# MICROCHIP PIC18F2423/2523/4423/4523

## PIC18F2423/2523/4423/4523 Rev. B2 Silicon Errata

The PIC18F2423/2523/4423/4523 Rev. B2 parts you have received conform functionally to the Device Data Sheet (DS39755B), except for the anomalies described below. Any Data Sheet Clarification issues related to the PIC18F2423/2523/4423/4523 will be reported in a separate Data Sheet errata. Please check the Microchip web site for any existing issues.

**FIGURE 1: SCK PULSE VARIATION USING TIMER2/2**

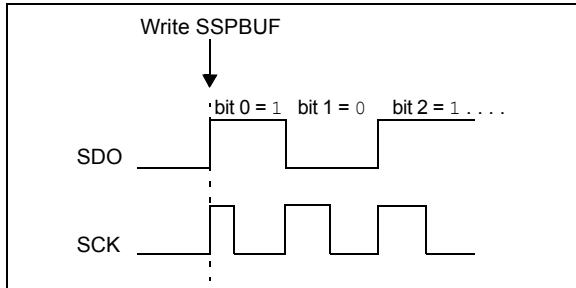
When the SPI is using Timer2/2 as the clock source, a shorter than expected SCK pulse may occur on the first bit of the transmitted/received data (Figure 1).

To avoid producing the short pulse, turn off Timer2 and clear the TMR2 register, load the SSPBUF with the data to transmit and then turn Timer2 back on. Refer to Example 2 for sample code.
